## CONDITIONS OF APPROVAL:

Open Issues: 10 These issues are currently being filtered

#### Lot Standards (Lots 2-39 & 41-45)

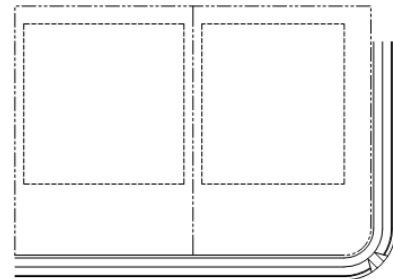
[lance.fittro@franklintn.gov](mailto:lance.fittro@franklintn.gov) Applicant shall revise the note added on C2.0 to specifically reference Lots 2, 3, 19, 22, 23, 41 and 42, all of which are shown to have PUDAE's on the residential lot. Additionally, applicant shall identify these lots as Critical Lots for Public Infrastructure on the Development Plan, Site Plan and Final Plat.

At Site Plan stage, the applicant shall provide clear access to all stormwater BMP's. Any access easement provided to these areas which cannot be traversed by maintenance equipment shall not be acceptable.

Building permit submittals for these lots shall indicate that there is no encroachment with structures, walls, fences, utility or other appurtenances, or steep slopes which would limit access to the stormwater management features for the development via the access easement across the residential lot. Applicant shall verify that the remaining building envelope is adequate for the proposed home construction on each of these lots.

55' Lot (Nominal) - Single-Family Detached  
15' Front Yard  
15' Corner Yard  
5' Side yard  
10' Rear Yard

Typical House Square Footage - 2,200 - 3,000 sf

100' Lot (Nominal) - Single-Family Detached  
40' Front Yard  
15' Corner Yard  
5' Side yard  
10' Rear Yard

Typical House Square Footage - 2,200 - 3,000 sf

Note: Building Envelopes Shall be Located Outside of any Easements as Shown in the Plan View Above.
